Yamaha FJ 1100 / FJ 1200 Inner Hub Modification for Billet Hub

The following must be done when using our billet hub.

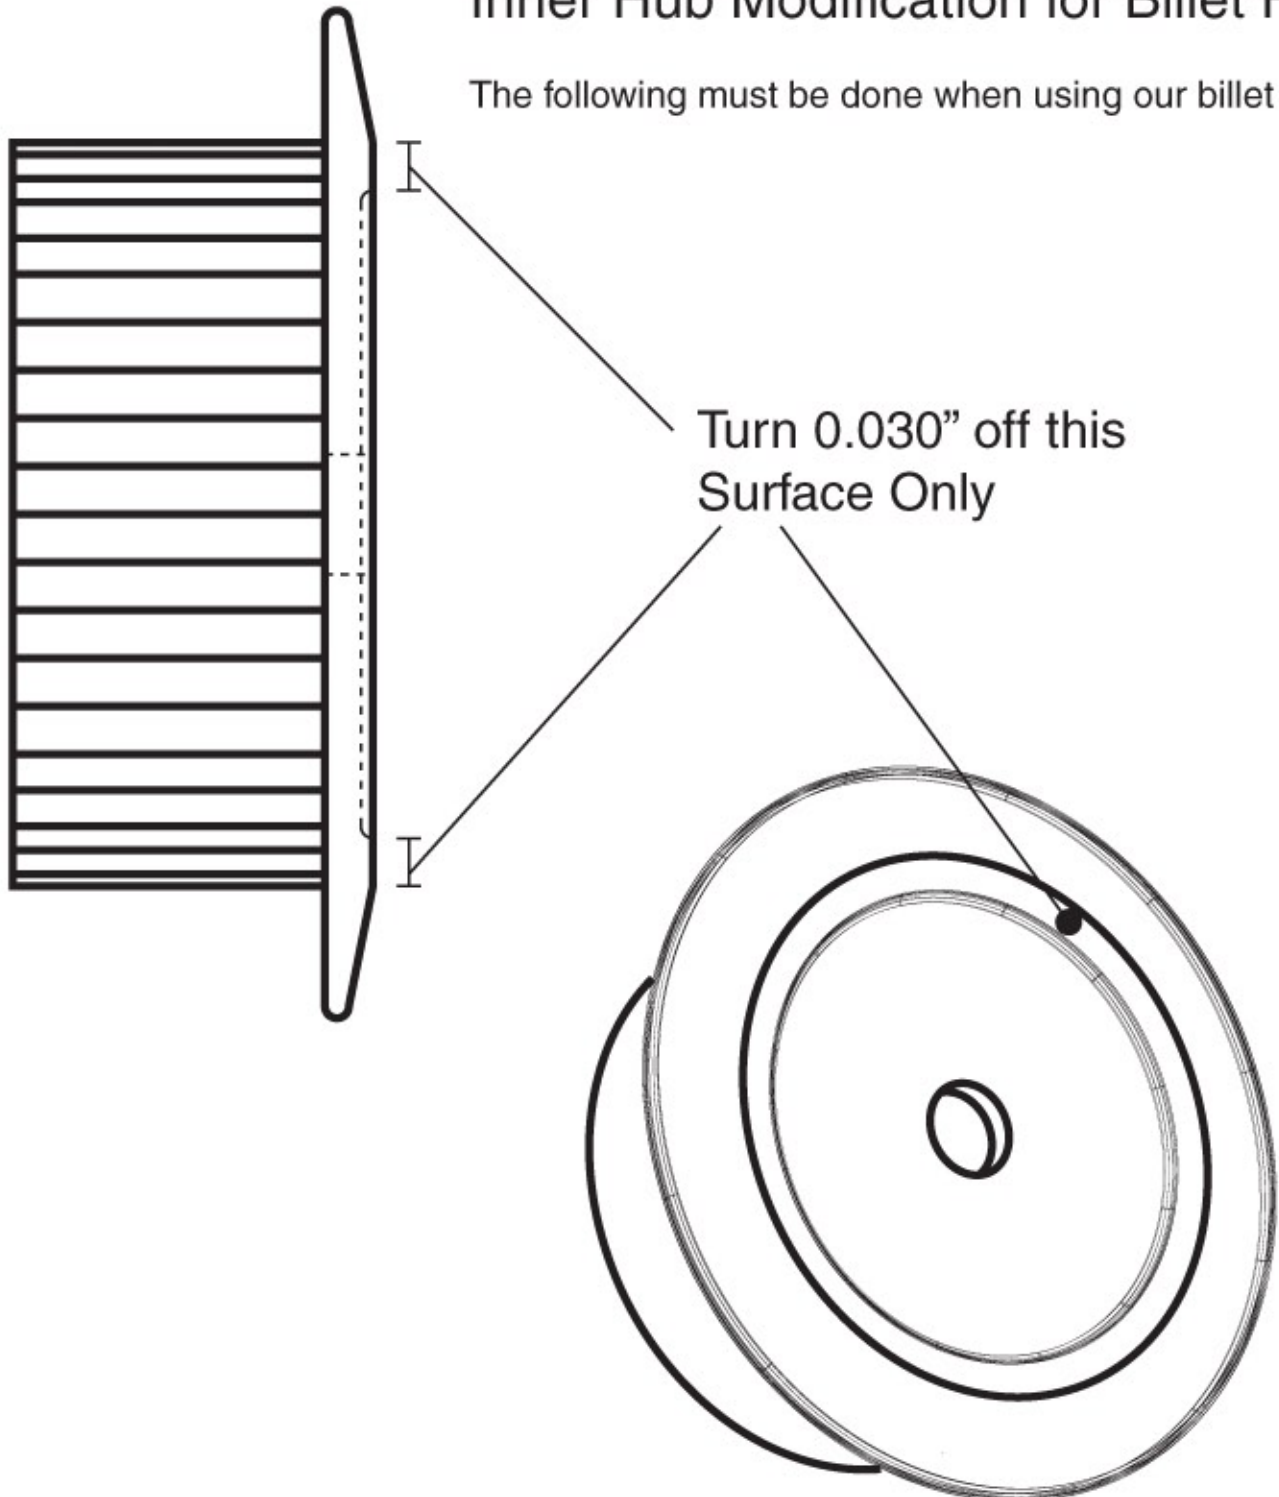
Turn 0.030" off this
Surface Only
